E8357A-02D**S E R V I C E****N O T E**Supersedes:
E8357A-02C**E8357A PNA Series RF Network Analyzers****Serial Numbers: 00000000 thru 46999999**

November 15, 2007

Situation:

Figure 1

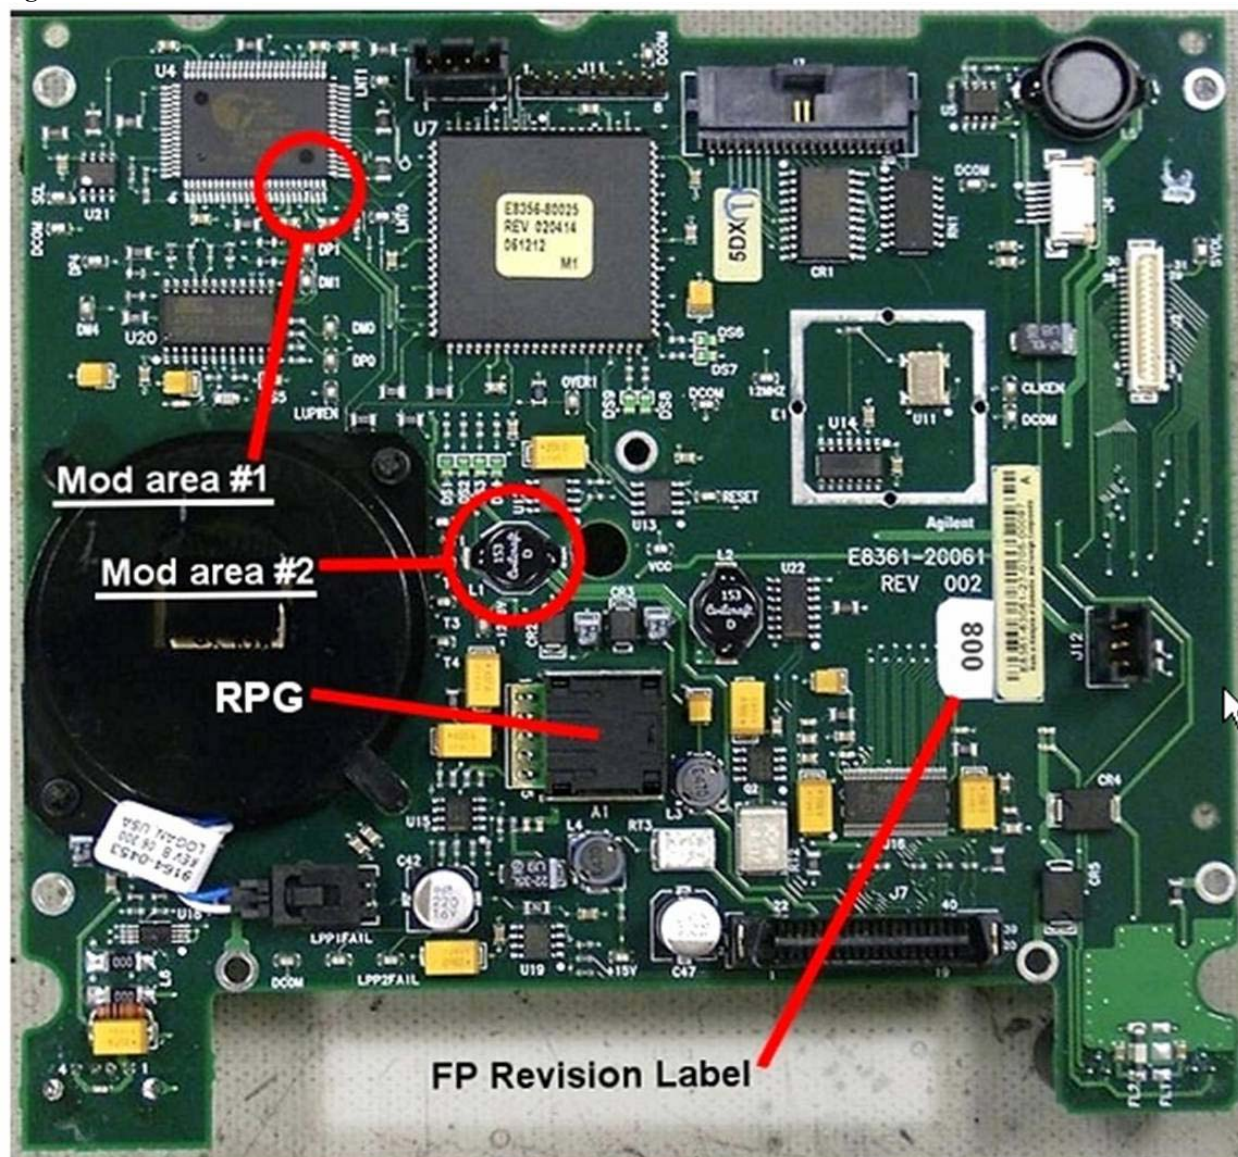
Refer to Figure 1 for the two modification areas to be addressed. Note that while this picture happens to show the FPI board completely removed from the front frame assembly, this is not necessary to perform the required modifications.

- Modification #1 consists of shorting two pins of U4 together with a small amount of solder.
- Modification #2 consist of removing L1.

Figure 2

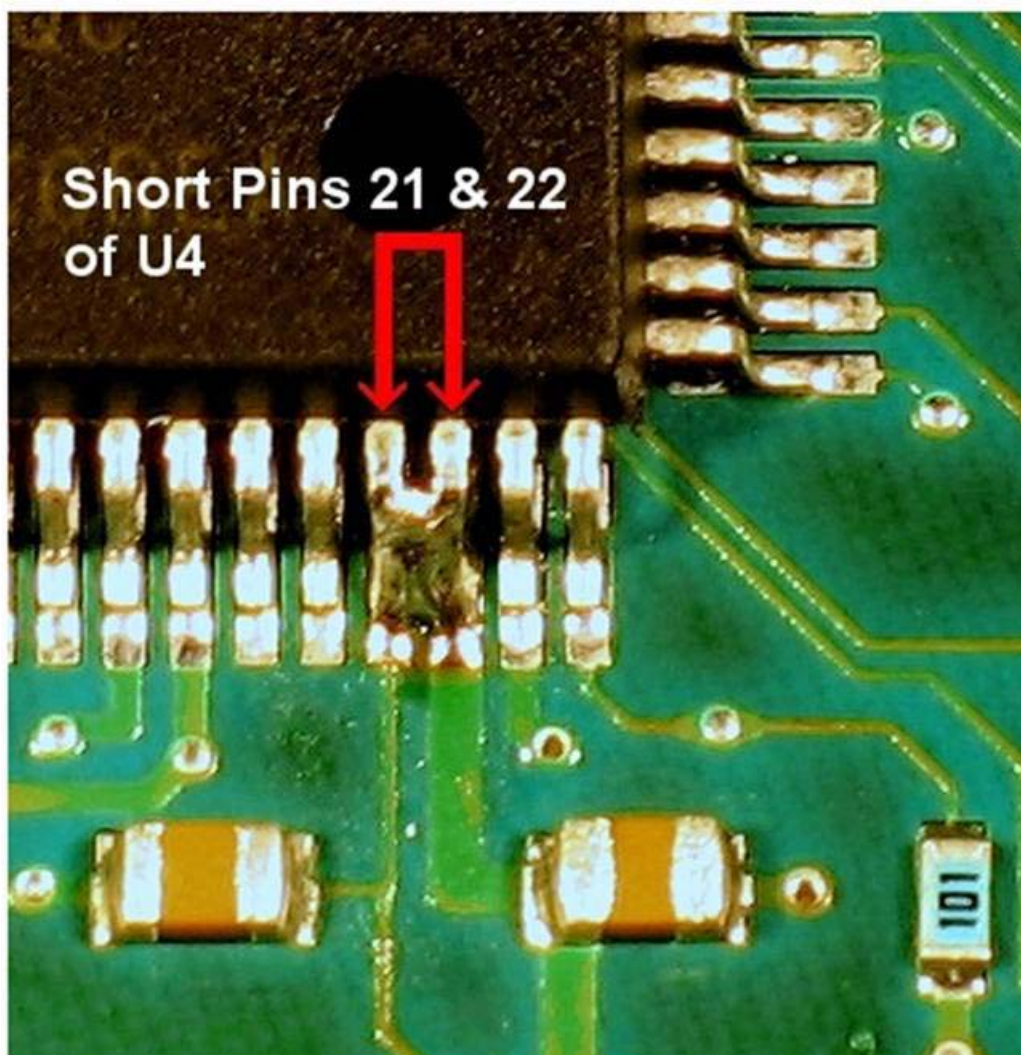
Carefully solder pins 21 and 22 together on U4. Refer to Figure 2 for the exact location. Use care so that no other pins are shorted. Use of a very fine tip soldering iron is recommended and a large work-task magnifying glass is very helpful.
